SUBJECT: REVIEW OF STAFF RELEASE RATE CALCULATIONS FOR
SALTSTONE

Docket No.: PROJ0734

REVIEW OF STAFF RELEASE RATE CALCULATIONS FOR SALTSTONE DISPOSAL FACILITY

Figure 1 – The Impact of Using non-Uniform Time-Stepping in the Staff Spreadsheet. Red curve is staff non-uniform time-stepping annual fraction oxidized. Maroon is uniform 50-yr time-stepping.

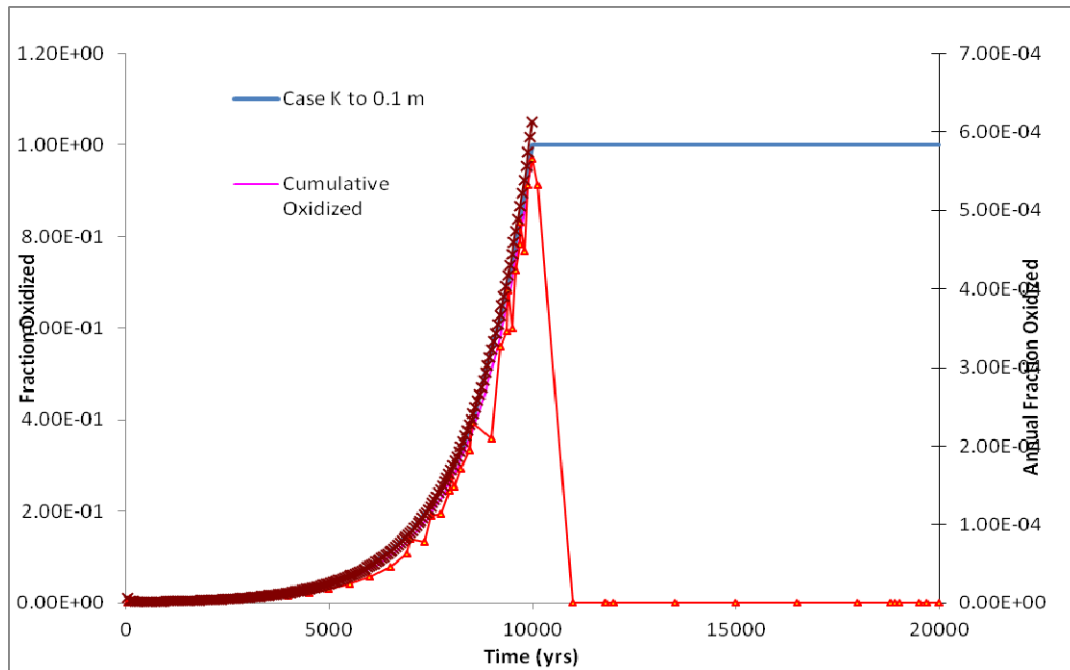
I also investigated the influence of time-stepping. The use of non-uniform time-stepping in the spreadsheet is a potential source of error. While the cumulative release rate curves are smooth, the fractional release rate curves are not. Figure 1 shows the results in the spreadsheet for a select case compared to a new calculation using a uniform 50 year time step. The error magnitude is on the order of 10%, which is not significant in this context but should be cleaned up if time permits and prior to archiving regardless.
